Determination 2012/044

The issue of a notice to fix for seven semi-detached townhouses in a retirement village building at 61 Te Arawa Street, Orakei, Auckland

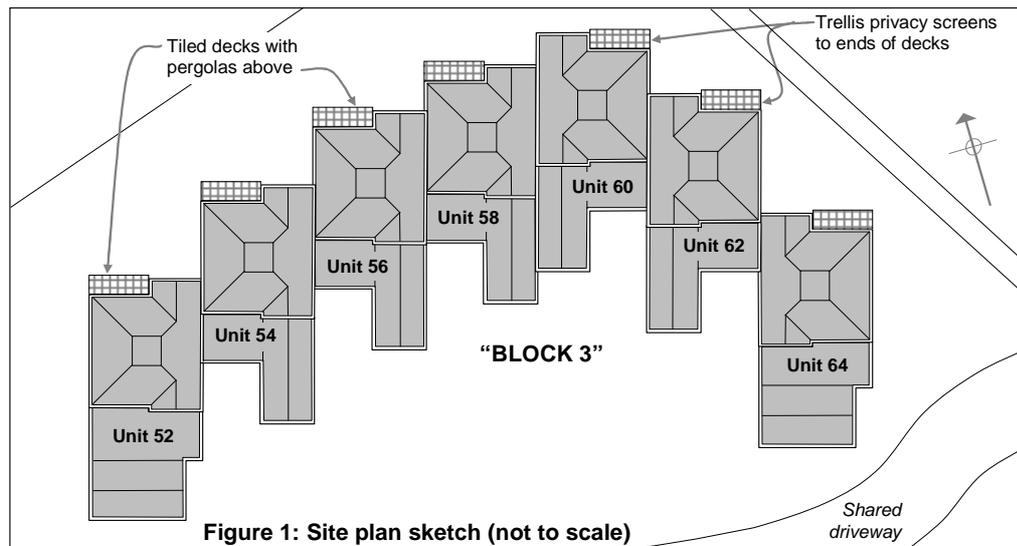
2.1 The building work considered in this determination is to a two-storey high building in a retirement village complex, “Block 3”, which accommodates seven semi-detached apartments with upper level decks as shown in Figure 1.
